PCN
Raspberry Pi 3A+ Revision 2 PCB

Product Change Note

Change of Raspberry Pi 3A+ PCB to Revision 2.

Image identification

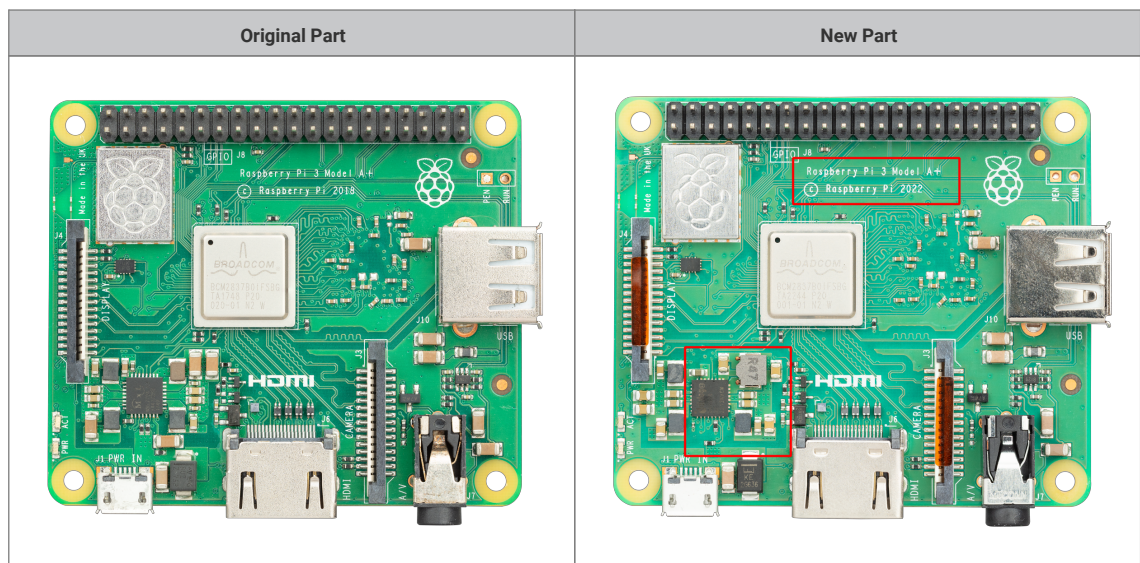
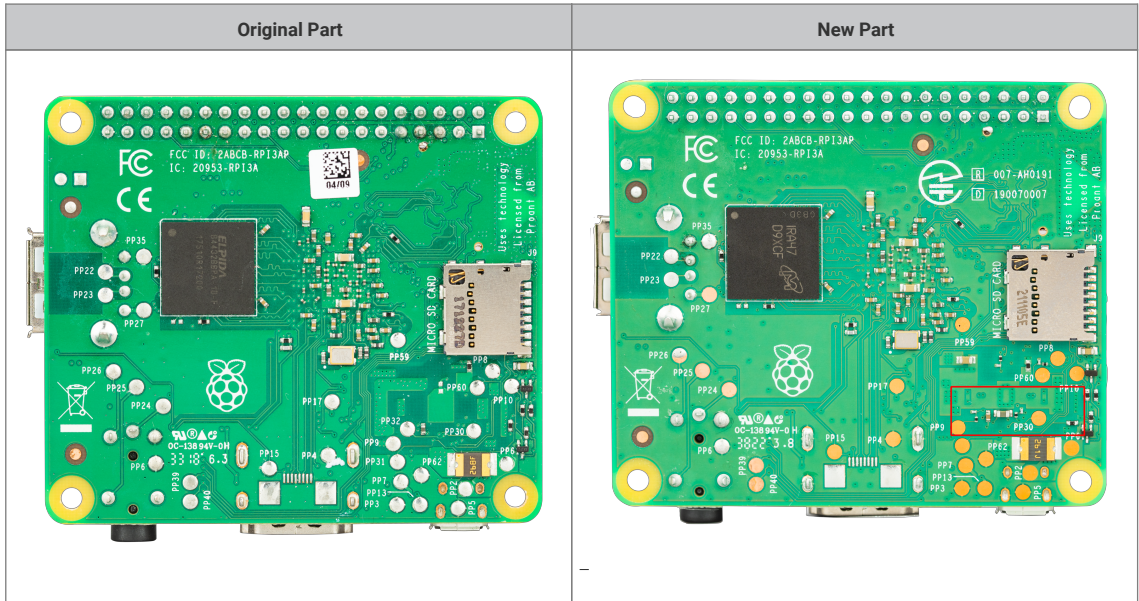
- New DA9090 PMIC.
- No other significant changes

- New DA9090 PMIC.
